PG&E Letter DCL-98-025

Docket No. 50-275, OL-DPR-80
Docket No. 50-323, OL-DPR-82
Diablo Canyon Units 1 and 2
Response to NRC Request for Additional Information
WCAP-14707 and 14708

**RESPONSE TO NRC REQUEST FOR ADDITIONAL INFORMATION
WCAP-14707 AND WCAP-14708**

Figure 4-1. Bobbin Coil Lissajous Signal for TSP with No Degradation or Magnetite

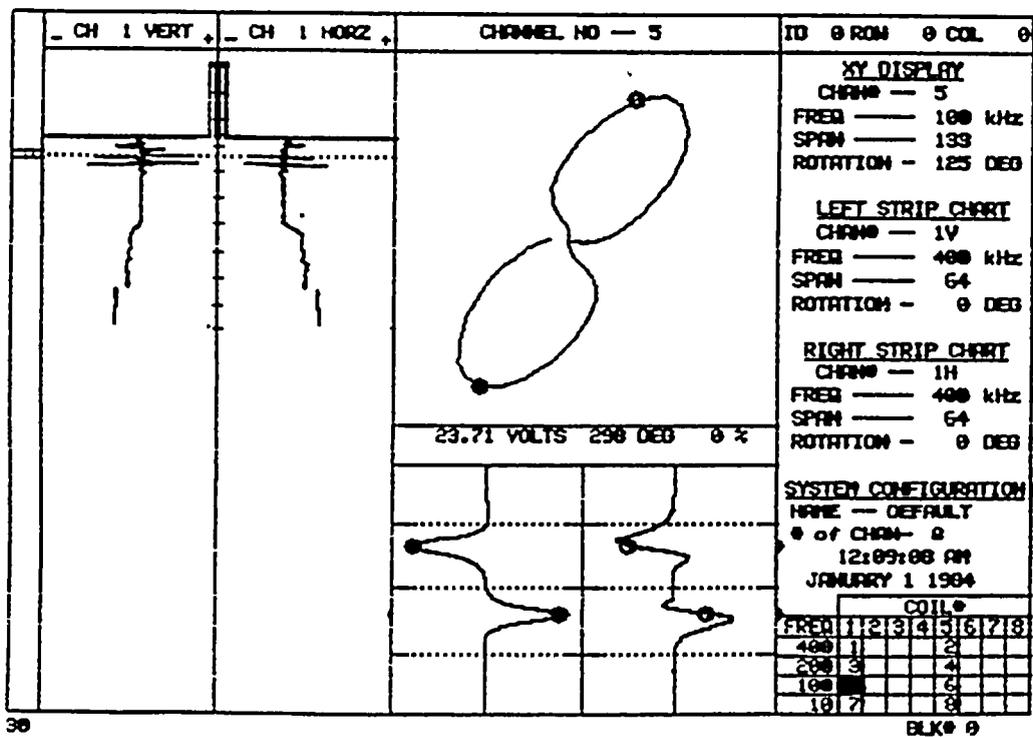
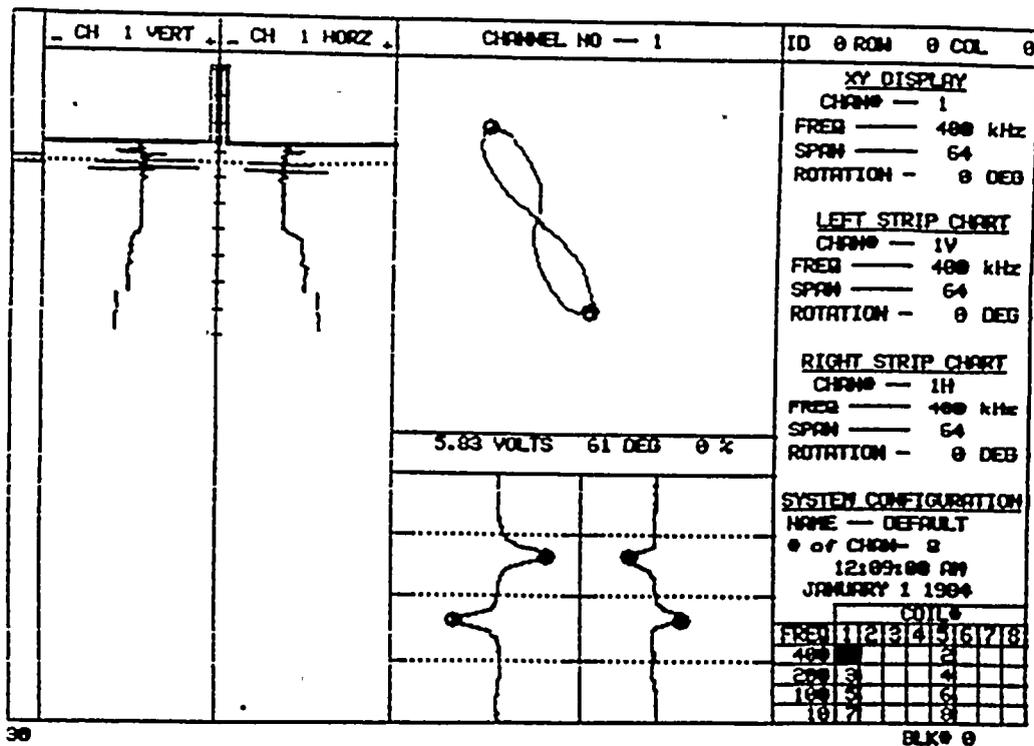
Discuss how one can directly verify, on a site-specific basis, that the TSP crevice conditions can be relied upon to ensure limited TSP displacement.

Bobbin coil NDE can be used to detect TSP corrosion and magnetite in the crevice region. This analysis methodology has been used historically to identify "locked" tube-to-TSP crevices at the top TSP in support of the corrective action evaluations in response to NRC Bulletin 88-02 relative to U-bend tube rupture. Figure 4-1 shows the

typical bobbin response as a figure 8 lissajous from a TSP with an open crevice and no TSP corrosion. Figure 4-2 shows distortion of the TSP lissajous obtained from a TSP with a 20-mil deep, 1/4-inch wide, 360 degree circumferential groove machined in the center of the TSP. This signal response is typical of TSP corrosion signals that preceded development of dents in operating plants. The accumulation of high density magnetite in the crevice causes an interference or distortion in the TSP signal. Figure 4-3 shows the same TSP simulant as Figure 4-2, but the groove was filled with magnetite. The "spike"-like signals represent the iron oxide influence and provide insight to characterize a TSP intersection.

Figure 1. Elemental Composition Profile of 120 Degree Sector
Dampierre Tube Support Plate Crevice

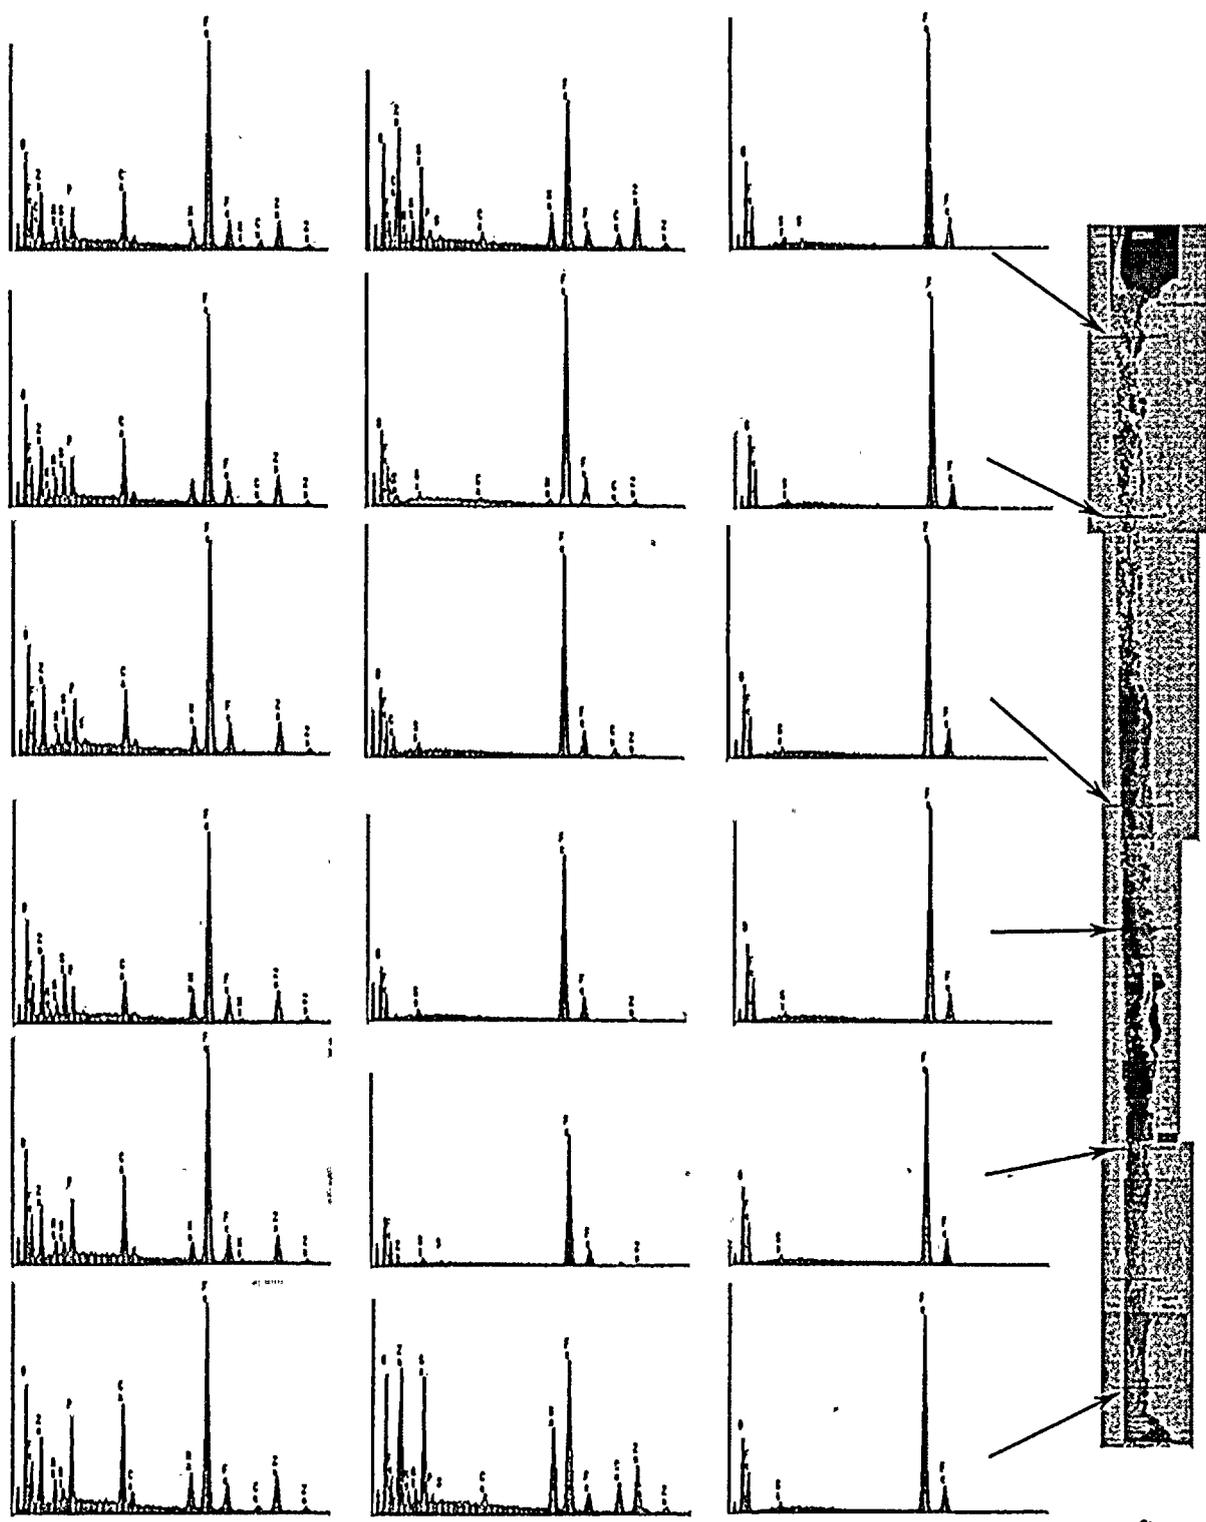
Provide the technical basis for concluding that the Dampierre-1 test results (i.e., pull force and leak rate testing, before and after chemical cleaning) are applicable to all TSP intersections in all Model 51 steam generators despite potential differences in the TSP crevice conditions given differences in TSP location, SG service life, secondary side water chemistry, chemical cleaning process, etc.

Figure 1 shows, on the right side of the figure, a photographic reproduction of the metallographic, axial cut, cross-section of a crevice from the Dampierre 1 retired SG as it was examined at the tube examination facilities of Westinghouse Electric Company. This intersection was not dented. The photograph shows just the edge of the outside diameter (OD) of the Alloy 600 MA tubing on the left, the adjacent crevice deposit, and on the far right, a portion of the carbon steel of the TSP. The eighteen spectra portrayed in six rows of three are from the energy dispersive X-ray (EDS) spectroscopic examination of the crevice deposits immediately adjacent to the tube (left column), in the central region (middle column), and adjacent to the TSP (right column). The approximate corresponding axial position of each row is designated by a reference arrow to the metallographic cross section. The data provided show that the elemental distribution within the crevice favors the concentration of silicon, phosphorous, zinc, aluminum, magnesium, iron, and oxygen containing deposits in the layer adjacent to the tube and across the width of the crevice at both the upper and lower openings. Other species such as copper and sulfur are also reported. The central region of the

crevice, both axially and radially, is predominantly filled with compounds formed from iron and oxygen. Supporting data in the form of electron probe microanalysis provide an area map of the elements and shows regions, for example, with common elements occupying the same area, supporting their presence there as compounds. In addition, X-ray diffraction analysis was performed to determine crystal structure, with the report of crevice compounds such as magnetite (Fe_3O_4), hematite (Fe_2O_3), silicon dioxide (SiO_2), manganese oxide (Mn_2O_3), willemite (Zn_2SiO_4), calcium phosphate hydrate ($\text{Ca}_3(\text{PO}_4)_2\text{nH}_2\text{O}$), xonotlite ($\text{Ca}_6\text{Si}_6\text{O}_{17}(\text{OH})_2$), goethite ($\text{FeO}(\text{OH})$), and others.

The porosity of the deposits adjacent to the tube and the TSP is low, i.e., in the range of 1 to 10 percent void. The central region of the 120 degree section has a higher porosity, ranging to 50 percent void (see Figure 1). The corresponding region of the 300 degree section has no corresponding void space (see Figure 2). This variation in porosity may represent the operational crevice condition or it may be an artifact of sample preparation. There is a possibility, for example, that the cutting and polishing operations resulted in some crevice material dropouts that contributed to this apparent porosity. This is partly supported by examination of the micrographs, which show regions where the deposit forms bridges across the crevice with adjacent and irregular void patterns suggestive of material that dropped out. Figure 3 shows this in an enlargement of a portion of the 120 degree section.
